Work Order ID 74687

Item Name: Crosstube Fwd

DART AEROSPACE LTD	Work Order:	74687
Description: Crosstube High Fwd (407)	Part Number:	D407-667-105
Inspection Dwg: D407-667-145	Rev: C	Page 1 of 1

DRAWING NO. D407-667-145	TITLE CROSSTUBE ASS'Y (407 HIGH FWD)	REV. C	DART AEROSPACE LTD ENGINEERING ORDER		D.E.O. NO. D407-667-145-C-1	SHEET NO. SHEET 1 OF 1	SCALE NTS
DRAWN 47	CHECKED ASS	MFG. APPR. 128	APPROVED WD		DE APPR. H		
DATE 11.07.15	DATE 11.07.22	DATE 11.07.22	DATE 11/07/22		DATE 11.07.21

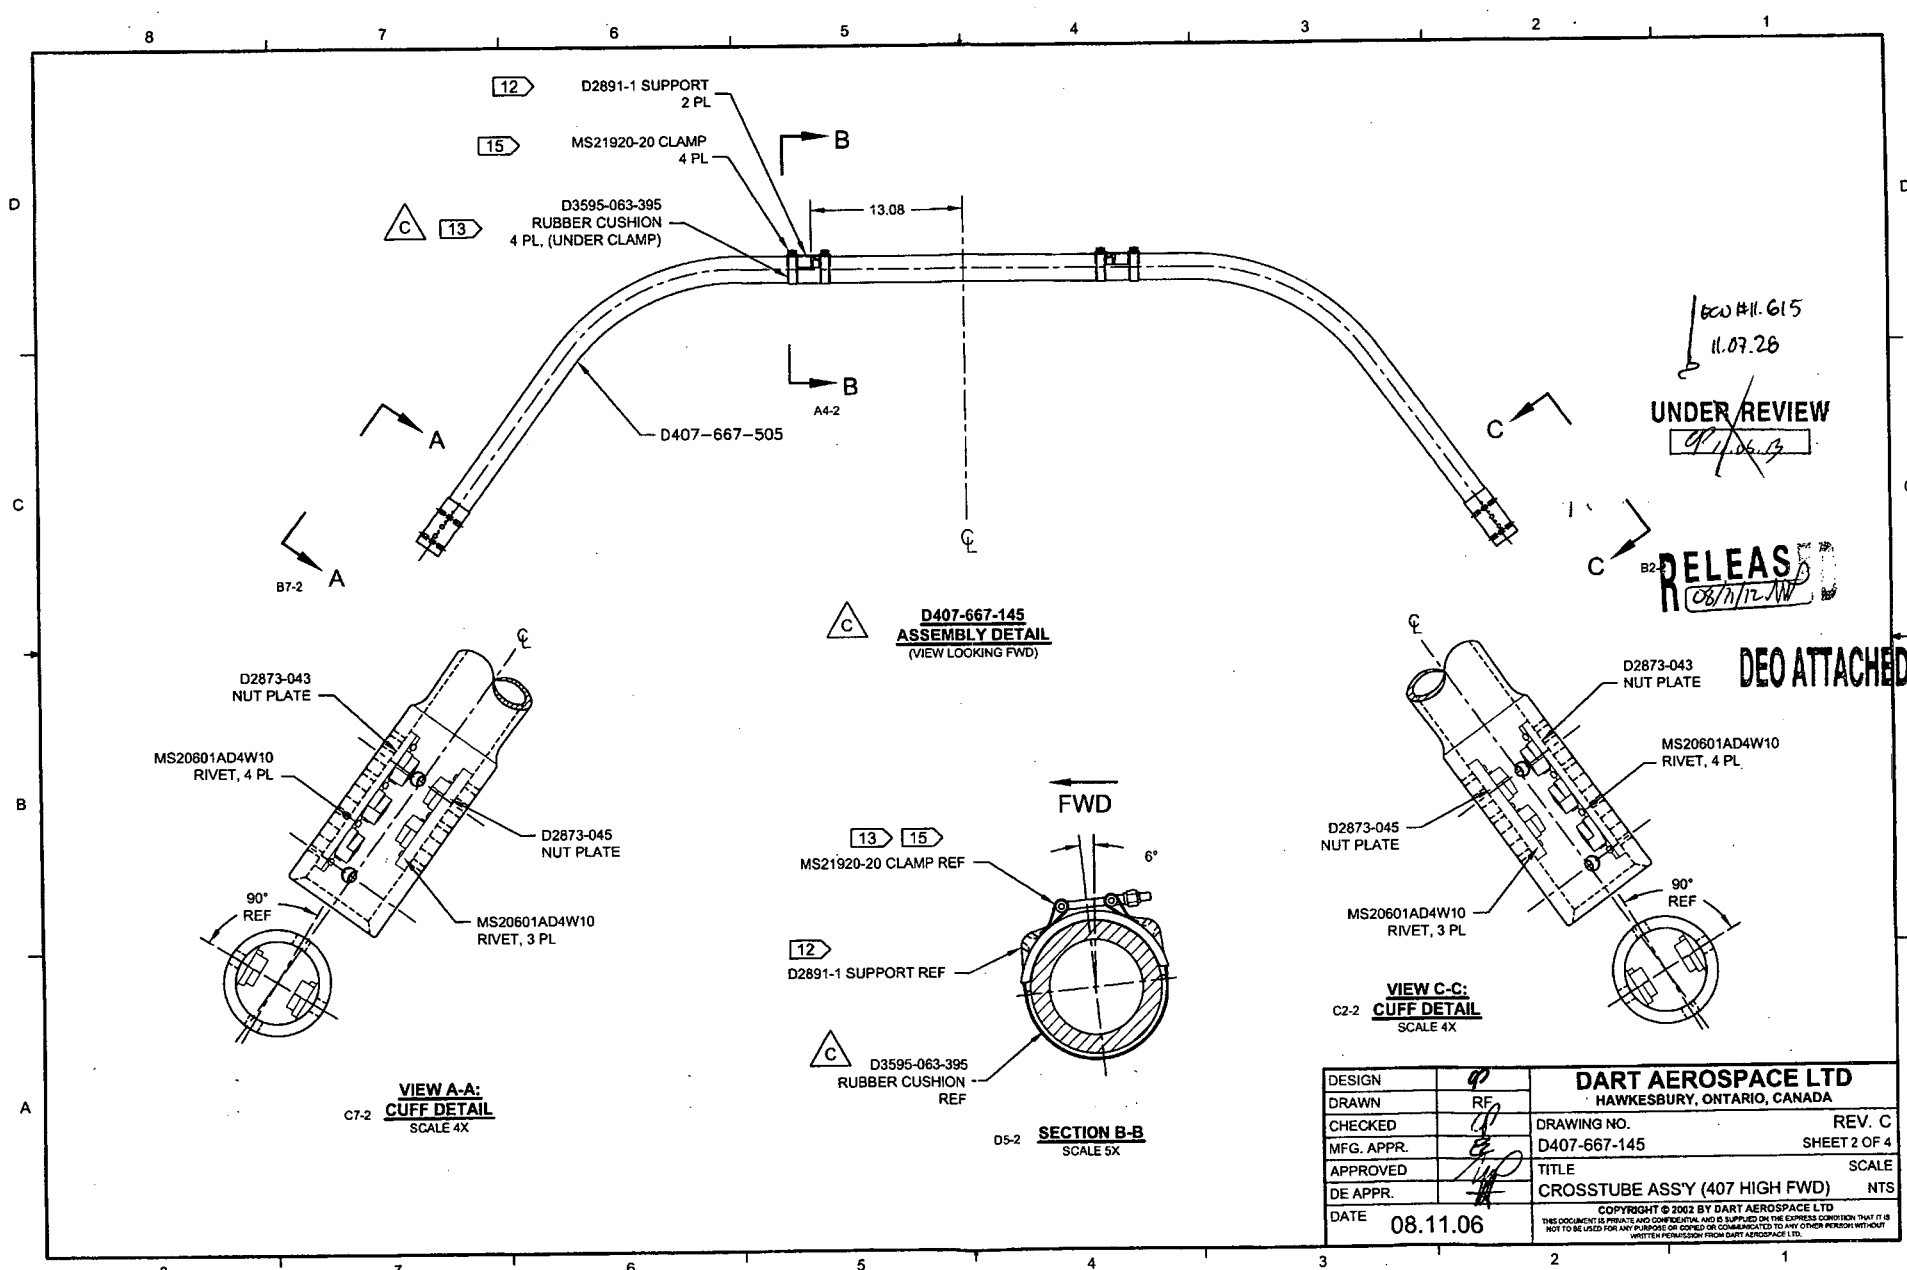
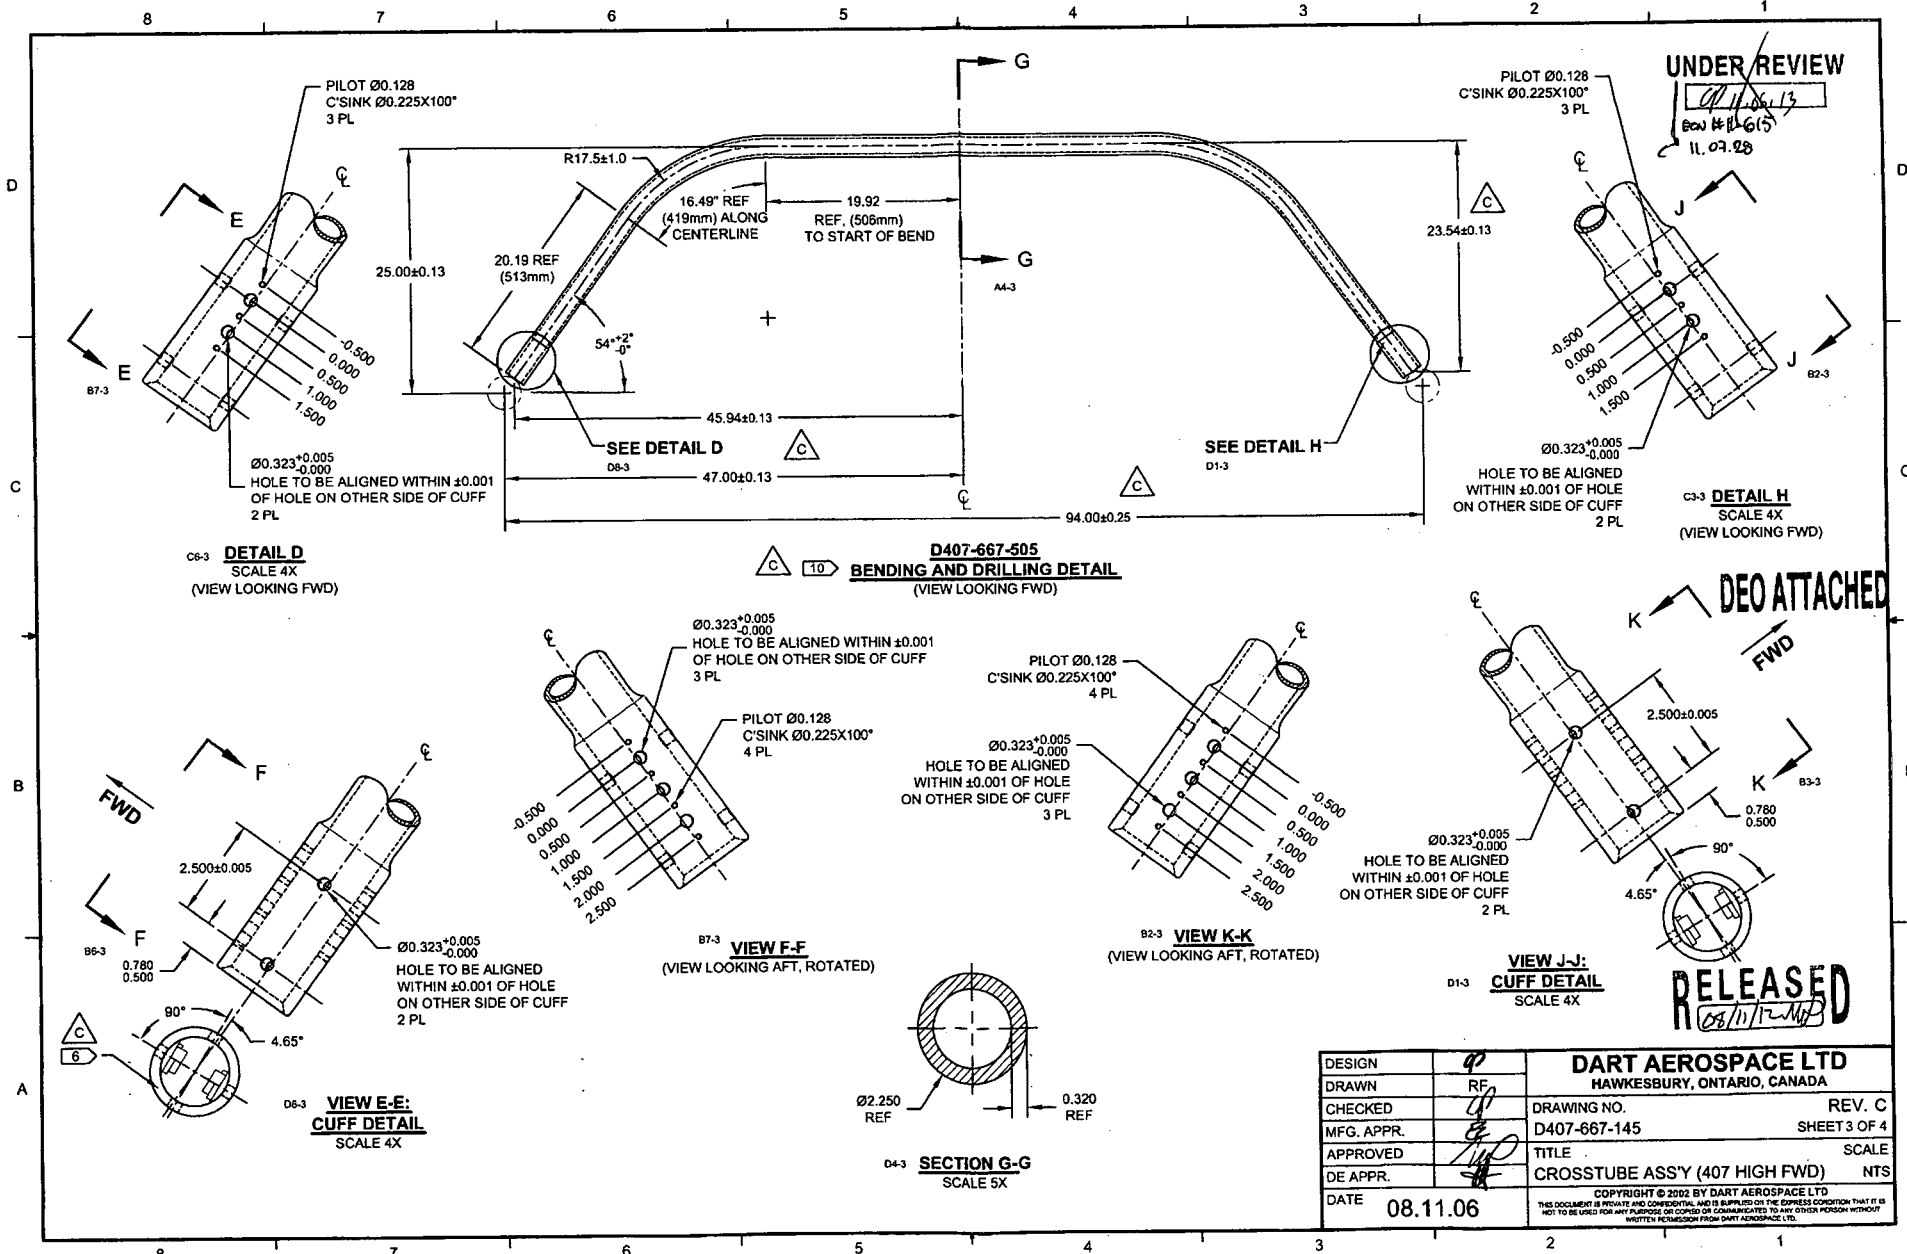
PURPOSE:

REPLACE MAGNOBOND WITH PROSEAL.

NOTE 12 & 15, SHEET 1 IS AMENDED AS FOLLOWS:

- 12) TO INSTALL D2891-1 SUPPORT: ABRABE MATING SURFACE OF SUPPORT AND CROSSTUBE WITH 180-GRIT SANDPAPER AND REMOVE RESIDUE WITH MEK (OR EQUIVALENT). APPLY A 0.04" TO 0.07" THICK LAYER OF PROSEAL 890 CLASS B-2 (OR AMS-S-8802 CLASS B-2) SEALANT TO MATING SURFACE OF SUPPORT.
- 15) TORQUE CLAMPS 80 TO 100 IN-LB. ENSURE AT LEAST 1.5 THREADS SHOWING IN SAFETY AND THAT NUT HAS NOT BOTTOMED-OUT AFTER TORQUING. **PRIOR TO PACKAGING, RE-CHECK TORQUE ON CLAMPS AFTER PROSEAL 890 SEALANT HAS CURED FOR 72 HOURS.**
